CERTIFICATE OF APPROPRIATENESS

Property: 1610 Cortlandt Street, tract 15A and 16A, block 115, Houston Heights Subdivision. The property includes a 3,989 square foot residence situated on an 8,246 square foot (62' x 133') interior lot.

Proposal: Alteration – Revisions related to exceeding the scope of work for a COA for an addition that was granted September 5, 2013 by Planning Commission Appeal. The applicant made the following deviations from their approved scope of work during construction:

STAFF SITE VISIT PHOTO 7/21/14

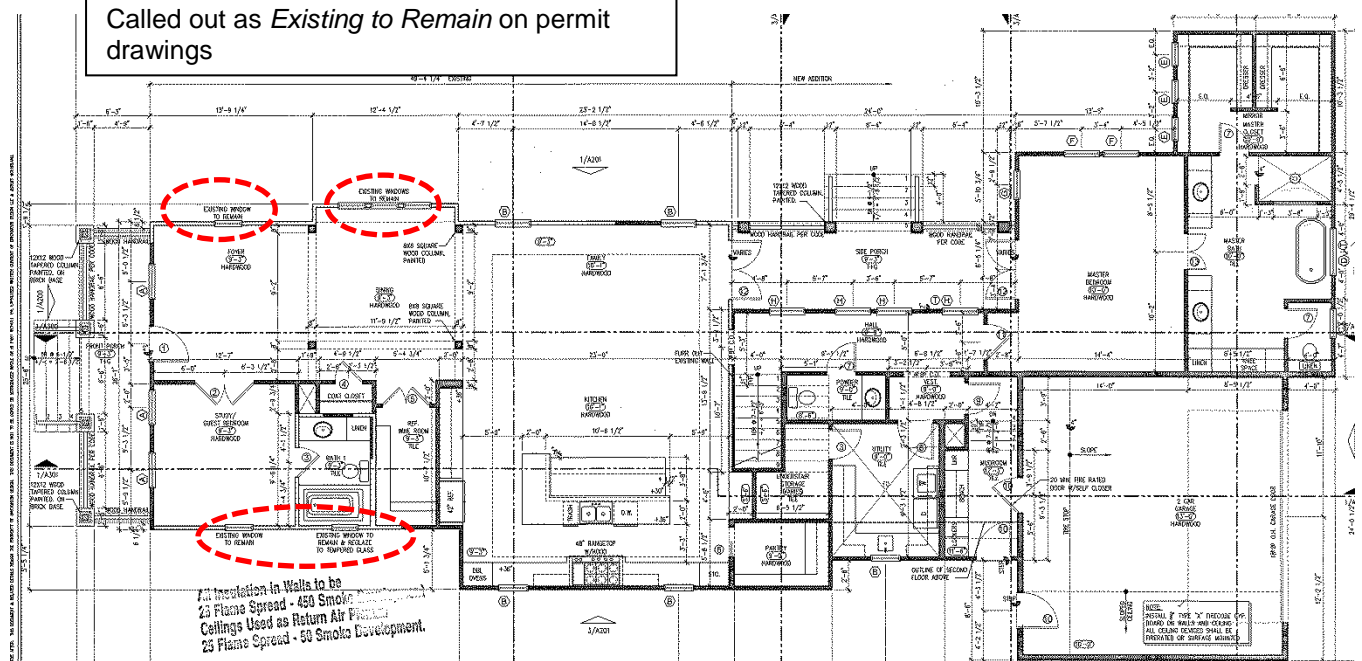
NEW SIDING AND 4 OVER 1 WINDOWS INSTALLED

4 over 1 windows used instead of 1 over 1

Salvaged historic 117 siding (painted grey) installed alongside new siding. . Applicant asserts that the siding towards the front of the house was from an earlier alteration to enclose the front porch.

Wood header above new cementitious window trim.

FIRST FLOOR PLAN

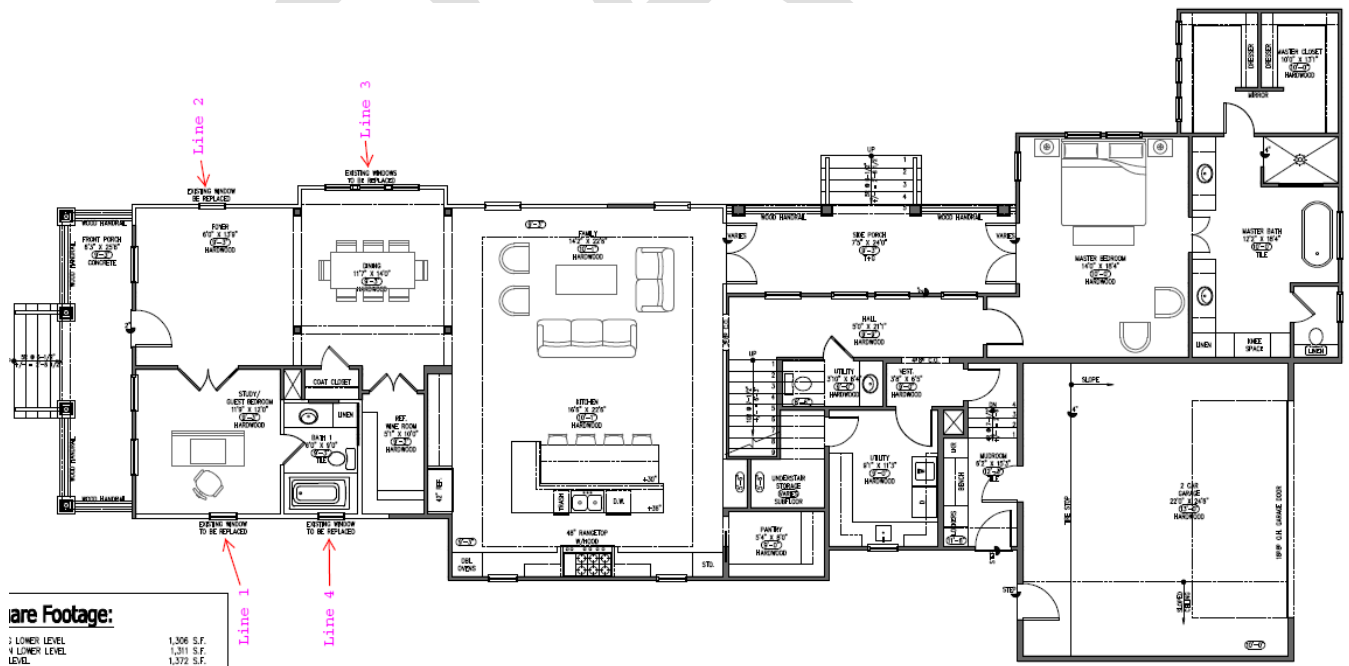
Called out as *Existing to Remain* on permit drawings

NEW 4 OVER 1 WINDOWS INSTALLED
